UNITED STATES PATENT AND TRADEMARK OFFICE

APPLICATION NO.	FILING DATE	FIRST NAMED INVENTOR	ATTORNEY DOCKET NO.	CONFIRMATION NO.
10/726,869	12/03/2003	Gabe Tomassoni	2224-00500	5423
23505	7590	04/19/2006	EXAMINER	
CONLEY ROSE, P.C.			ENGLISH, EVAN JAMES	
P. O. BOX 3267			ART UNIT	
HOUSTON, TX 77253-3267			PAPER NUMBER	
			3652

Office Action Summary

DETAILED ACTION

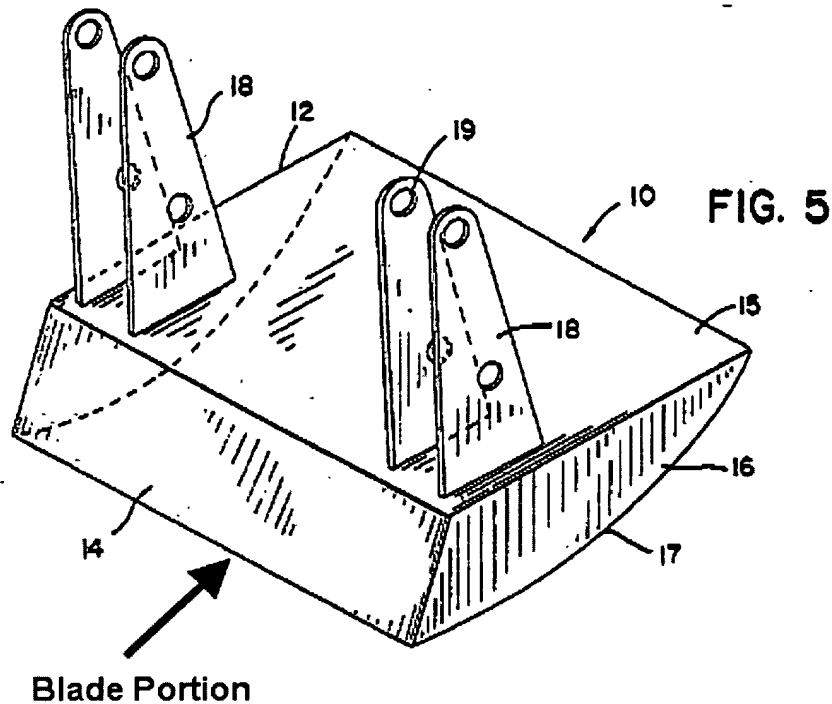
With respect to claim 9, Thobe discloses that the blade portion and the integral curved member 16 & 17 form a single integral unit (see Fig 5 and above figure).

With respect to claim 10, Thobe discloses that a shield portion 15 connect the blade portion to the integral curved member 16 & 17 (see Fig 5 and above figure).

With respect to claim 11, Thobe discloses that blade portion, the integral curved member 16 & 17 and the shield portion 15 are formed into a single integral unit (see Fig 5 and above figure).
